CITY OF FORT LAUDERDALE

CASE COMMENT REPORT

CASE NO. UDP-S24012

CASE:	UDP-S24012
MEETING DATE:	March 26, 2024
REQUEST:	Site Plan Level II Review: 189 Multifamily Residential Units in the Northwest Regional Activity Center
APPLICANT:	Sidney Miller
AGENT:	Josh Bailey, FSMY Architects & Planner
PROJECT NAME:	700 NW 1st Avenue Residences
PROPERTY ADDRESS:	700 NW 1st Avenue
ZONING DISTRICT:	Northwest Regional Activity Center-Mixed Use east (NWRAC-MUe)
LAND USE:	Northwest Regional Activity Center
COMMISSION DISTRICT:	2 - Steven Glassman
NEIGHBORHOOD ASSOCIATION:	Progresso Village Civic Association
CASE PLANNER:	Michael P. Ferrera

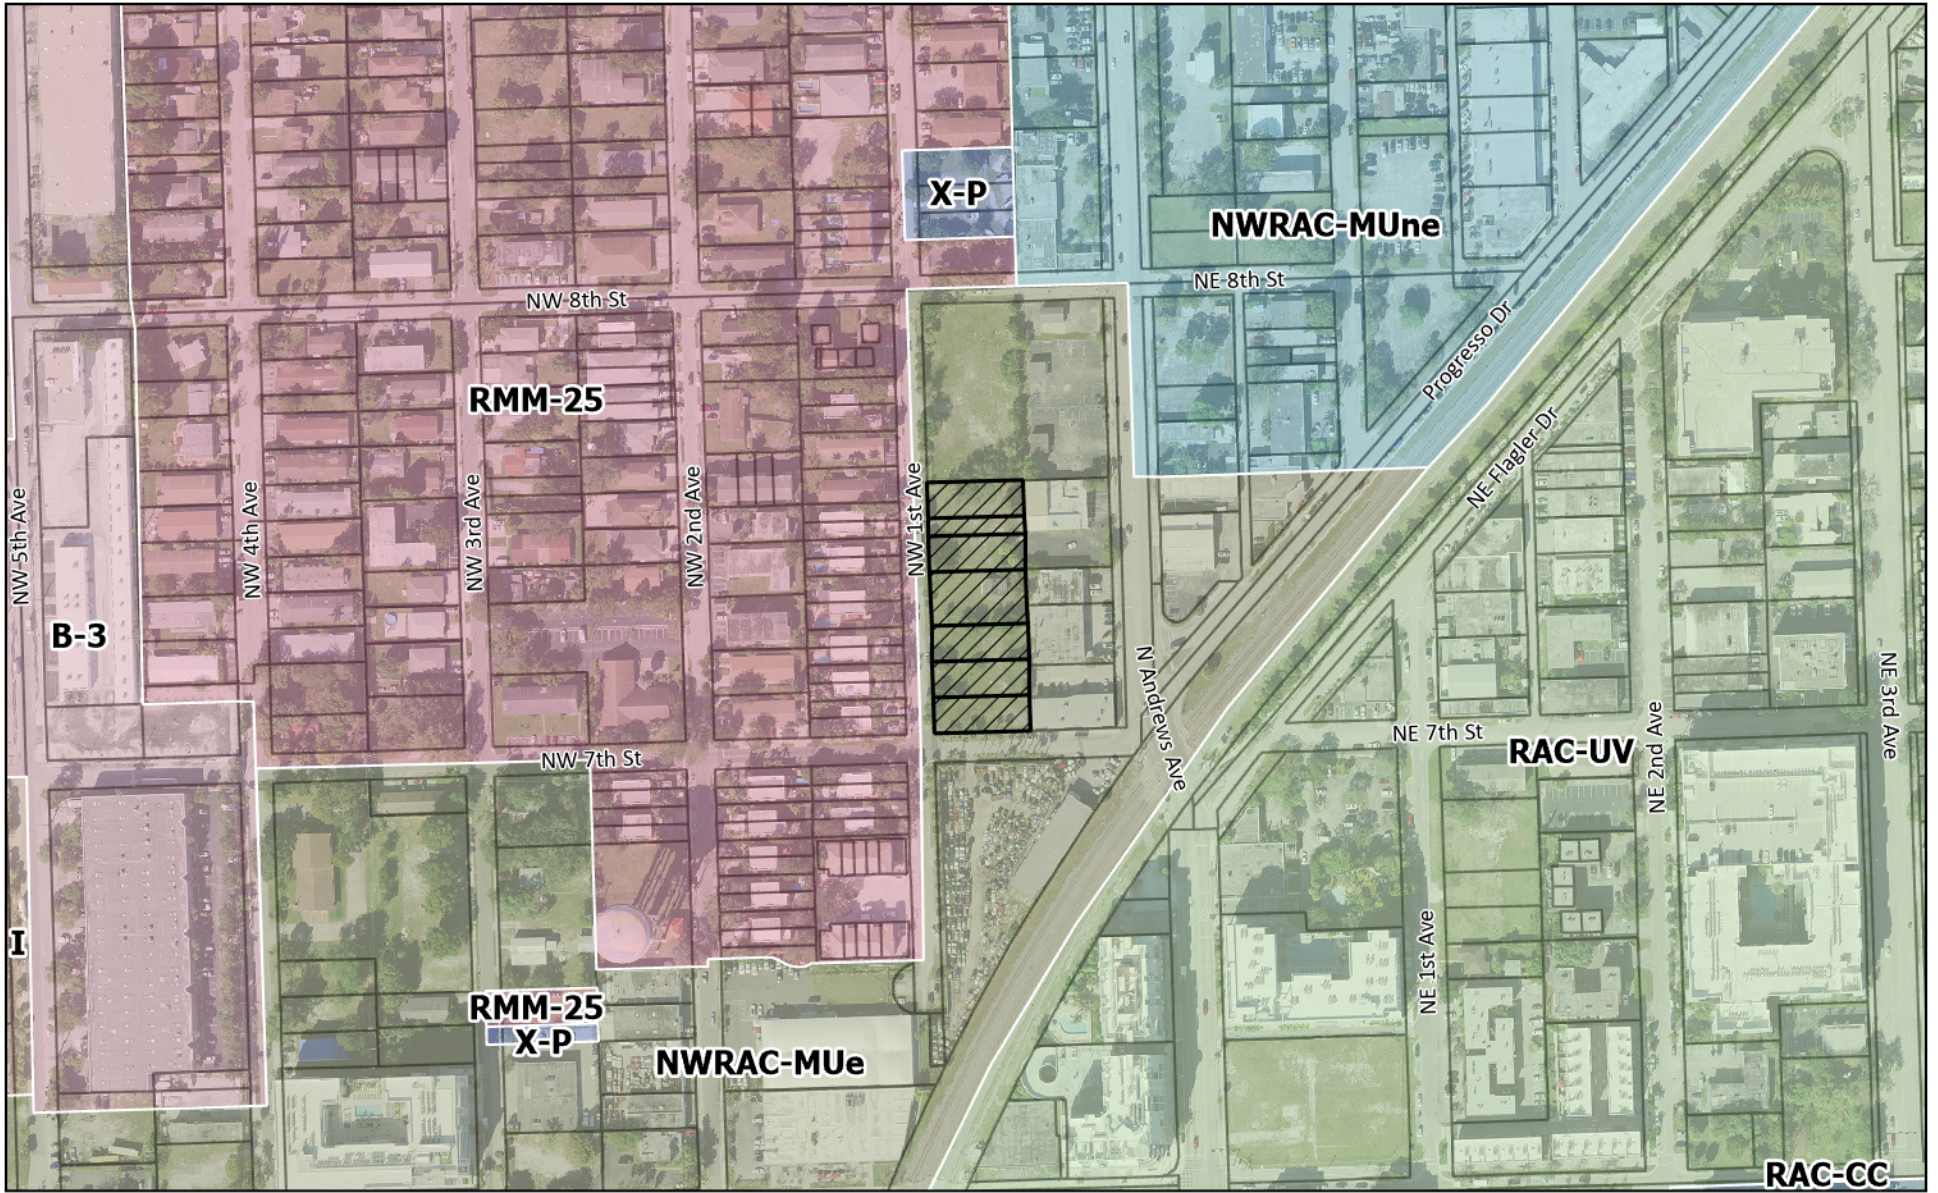
- i. B-13, *Towers contribute to the overall skyline composition*. As proposed, the overall skyline composition does not incorporate architectural/sculptural elements suitable for the project and context overall. Further improvements should be made to enhance the skyline composition.
